ADDENDUM #1

BUTANO STATE PARK FOREST HEALTH PROJECT

This document is in reference to the Request for Bids (RFB) for the Butano State Park Forest Health Project, dated January 30, 2023

Butano State Park: Operations Map - Old Growth MAMU Buffer
 USGS 7.5' Quadrangle: Franklin Point, California - San Mateo County T8S R4W

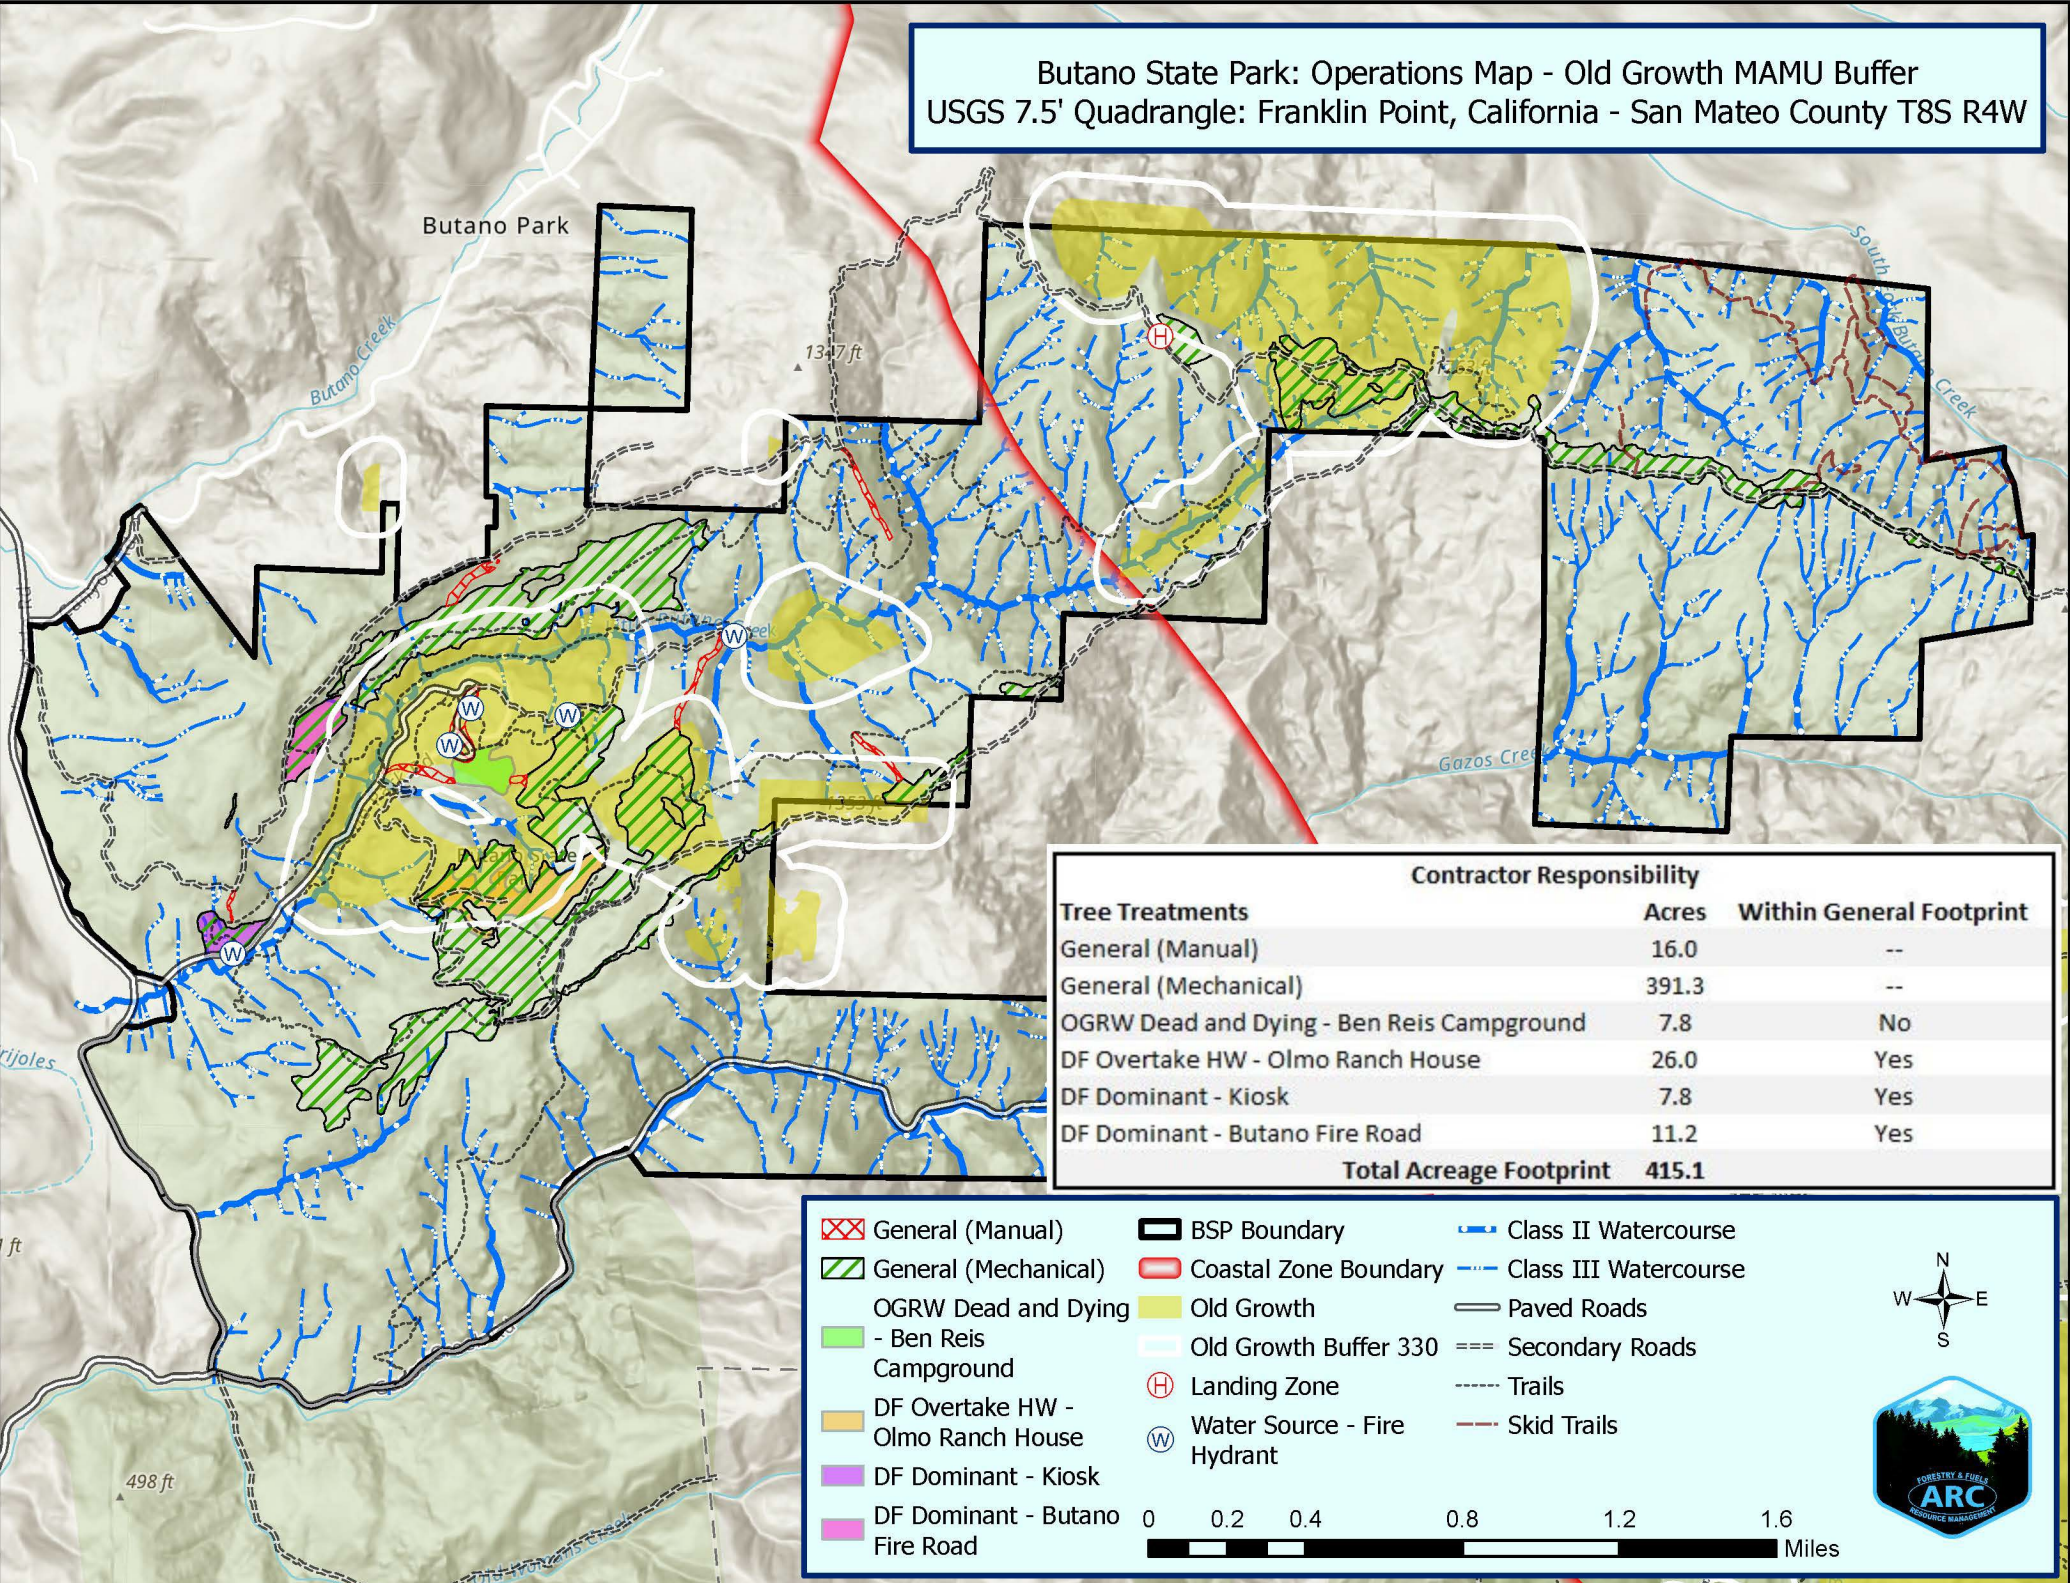
Marbled Murrelet Seasonal Restrictions:

- Between March 24 – August 5th, operations must occur **outside** of a 330’ habitat buffer surrounding old-growth redwood stands within the park. Areas outside of old-growth habitat and buffers constitute ~125 acres of the total treatment area.
- Beginning on August 5th, operations may occur **within old-growth habitat and buffers**, which constitutes ~290 acres of the total treatment area.

*See the end of this document for a map of the noise restriction buffers and old-growth habitat.

Note – water hydrants identified on the map are **not** functional.*
